ABSTRACT

TECHNICAL EVALUATION REPORT ON THE
PROPOSED DESIGN MODIFICATIONS AND TECHNICAL SPECIFICATION CHANGES
ON GRID VOLTAGE DEGRADATION
FOR THE
TURKEY POINT NUCLEAR GENERATING PLANT, UNITS 3 AND 4
(Docket Nos. 50-250, 50-251)

James C. Selan
Lawrence Livermore National Laboratory

FIGURE 1. TURKEY POINT UNITS 3 AND 4 ELECTRICAL ONE-LINE DIAGRAM

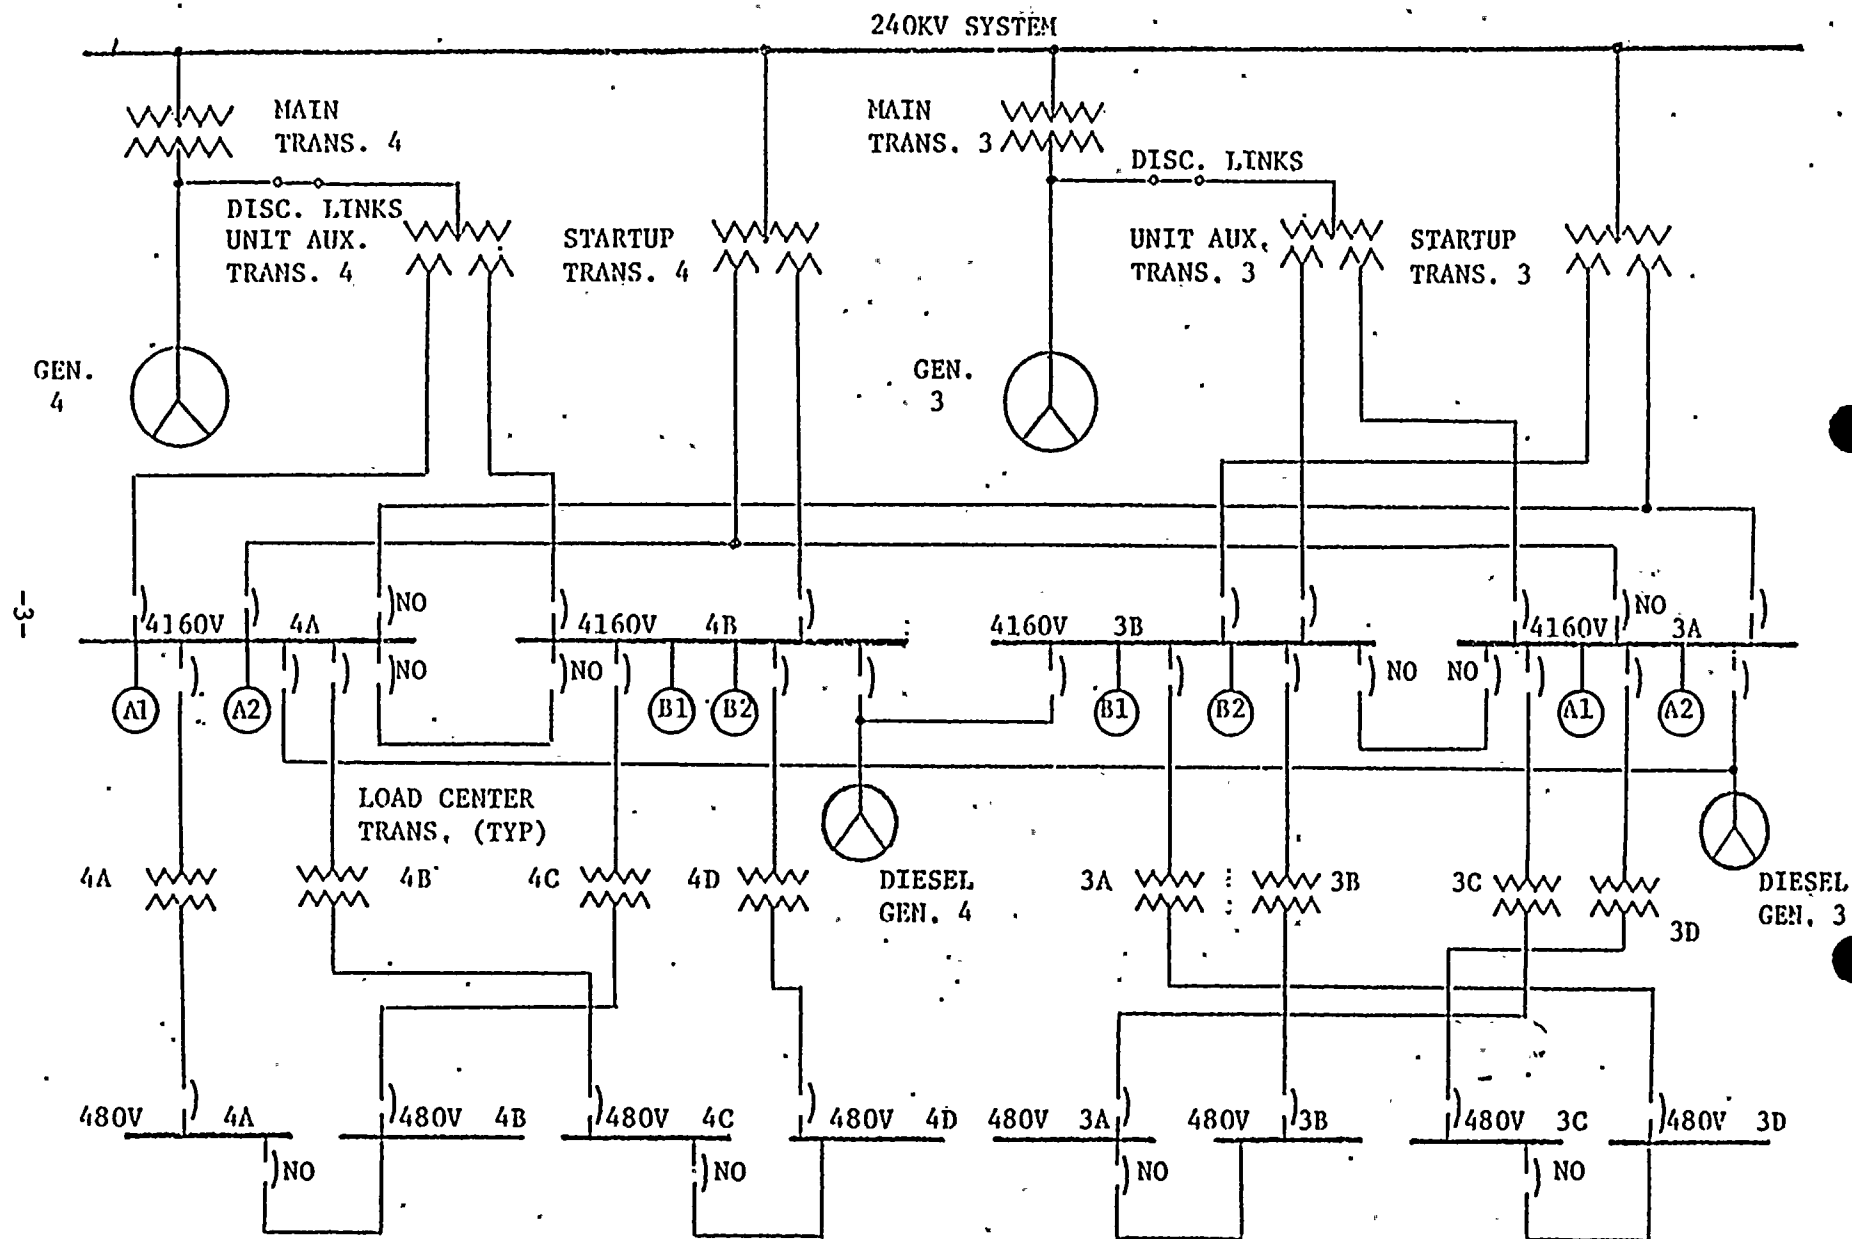
The present undervoltage protection design utilizes two undervoltage relays on each of the 4160-volt Class 1E buses (Buses A and B of Figure 1). The relays are instantaneous type HGA which respond at 40% - 50% of 4160 volts. These relays are used as loss-of-voltage protection.

The relay logic (2-out-of-2) is such that actuation of one relay (A1 or A2) on "A" bus in conjunction with the actuation of its interconnected relay (B1 or B2) on "B" bus will initiate the offsite source disconnection, load shedding, diesel generator starting and subsequent load sequencing on both buses. For example, the starting of diesel generator 3 and the disconnection of startup transformer 3 is initiated by the actuation of relay A1 on bus 3A and relay B2 on bus 3B or the actuation of relay A1 and the starting sequencing of diesel generator 4. This logic scheme results in two separate and redundant circuits.

- (1) The logic of the existing relays will be reconnected such that the offsite source disconnection, load shedding, diesel generator starting, and load sequencing will occur only for that bus on which the loss of voltage occurs. The logic will remain 2-out-of-2 but the scheme on bus A will now be independent of that on bus B.

- (2) The installation of two additional inverse time relays (type IAV) on each 4160-volt Class 1E bus. The function of these relays will be to protect the Class 1E equipment from sustained degraded voltages. These relays function similar to and utilize the same logic as the loss-of-voltage relays except via the "b" contact of the diesel generator breaker. Thus, when the breaker closes, the relays will be bypassed to disable the load shedding feature.
